**REMEDIATION SYSTEM EVALUATION**

**BAYOU BONFOUCA SUPERFUND SITE  
SLIDELL, LOUISIANA**

Report of the Remediation System Evaluation,  
Site Visit Conducted at the Bayou Bonfouca Superfund Site  
February 20-21, 2001

**Final Report Submitted to Region 6  
June 29, 2001**

FIGURE 1-1. SITE LAYOUT SHOWING AREAS OF CONTAMINATION AND EXTRACTION WELL LOCATIONS.

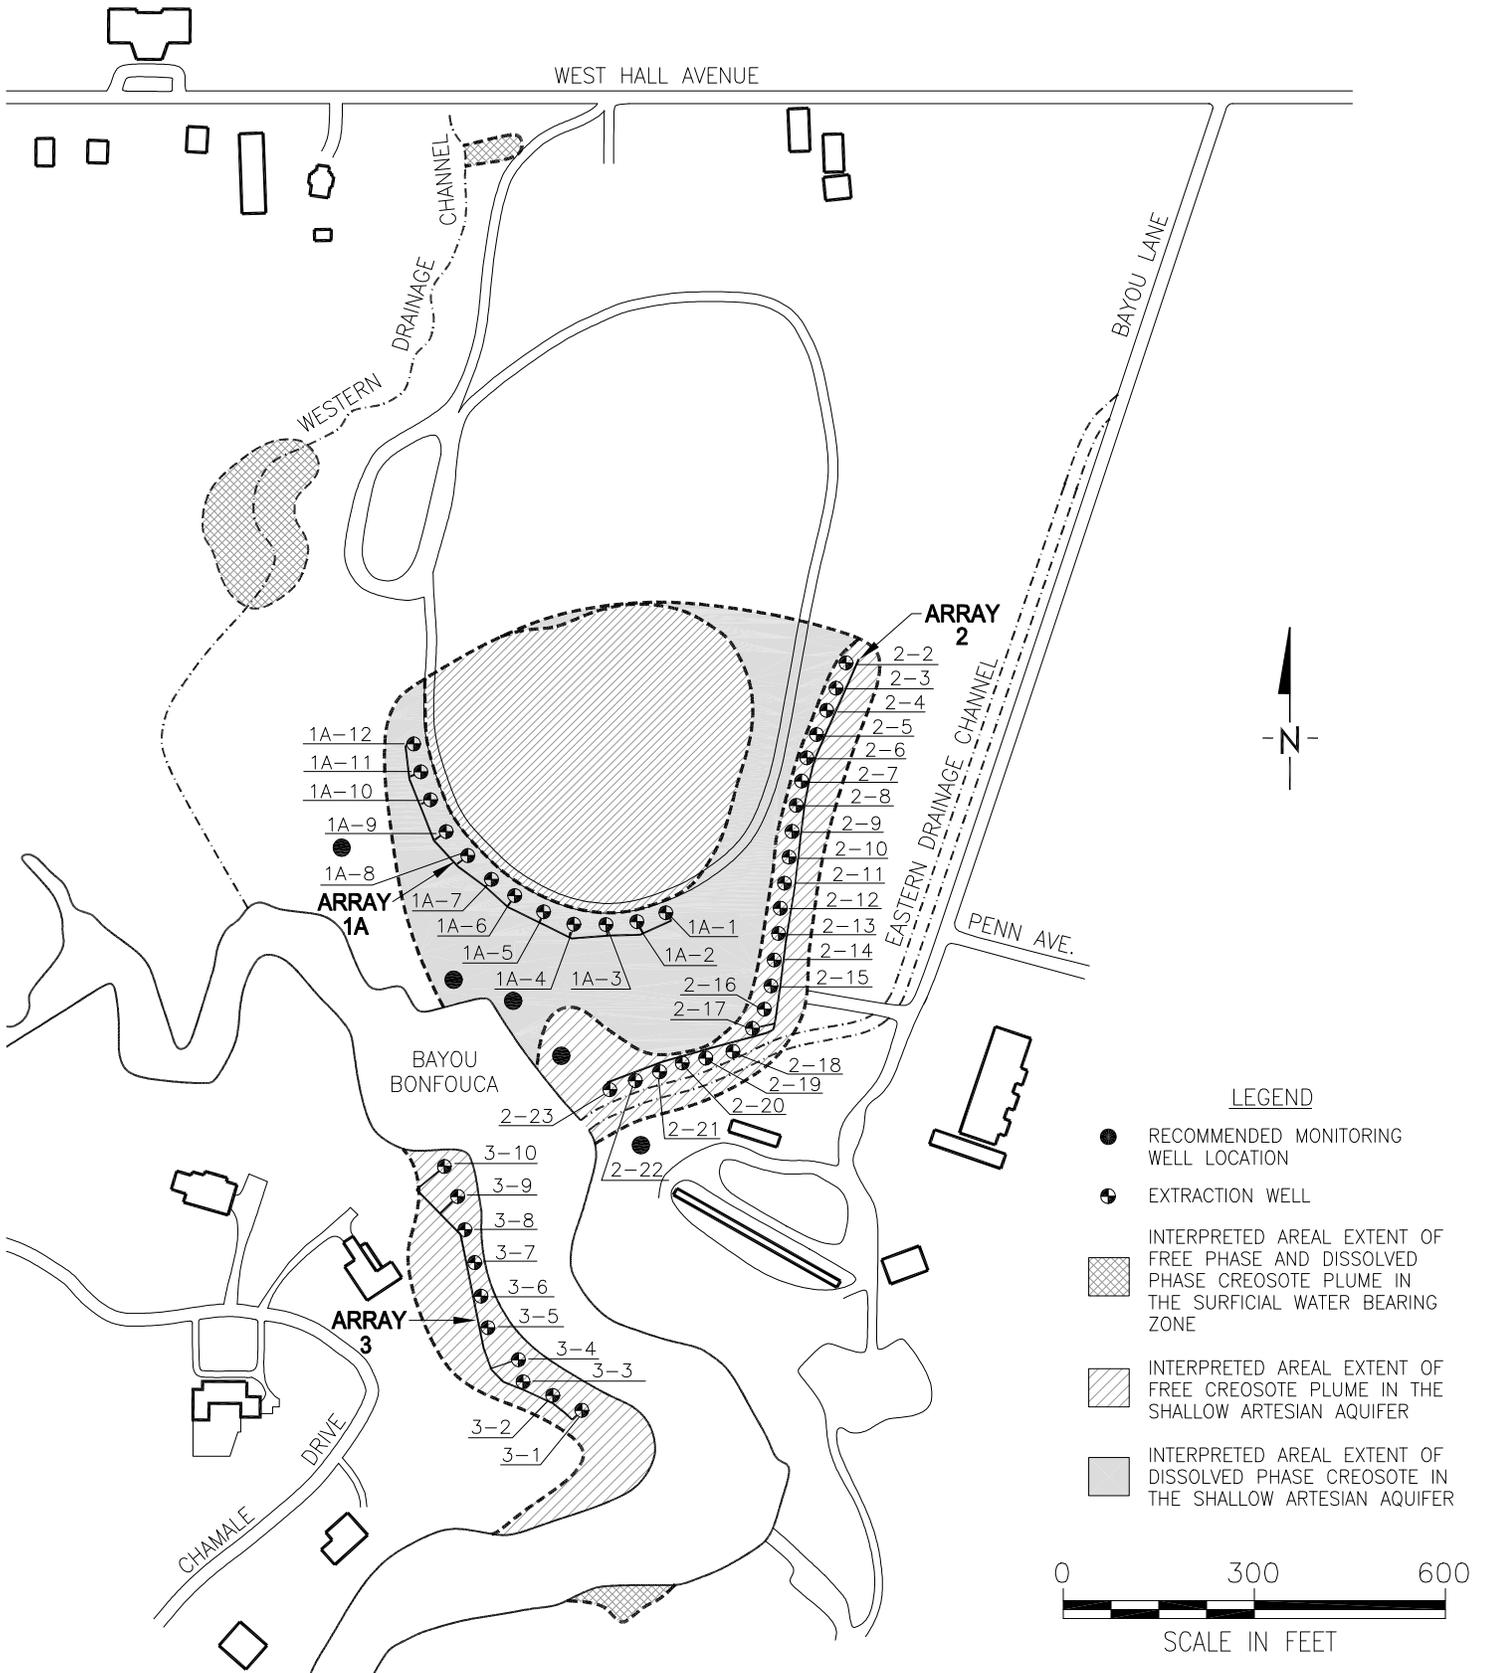
new wells, and samples should be collected from these new wells semi-annually and analyzed for BNAs. The following locations are suggested (see Figure 1-1 for these recommended locations):

It should be noted that the recommendation adjustments to the monitoring program will not completely delineate the plume or assure capture by Arrays 1a and 2. This program would, however, provide a strong indicator if capture is not provided. Furthermore, this recommended monitoring program does not address the offsite NAPL plume. As this offsite plume is not fully delineated and capture offered by the Array-3 wells has not been analyzed, the remedy is potentially inconsistent with the ROD objective requiring control of migration of PAH contamination Shallow Artesian Aquifer and other aquifers.
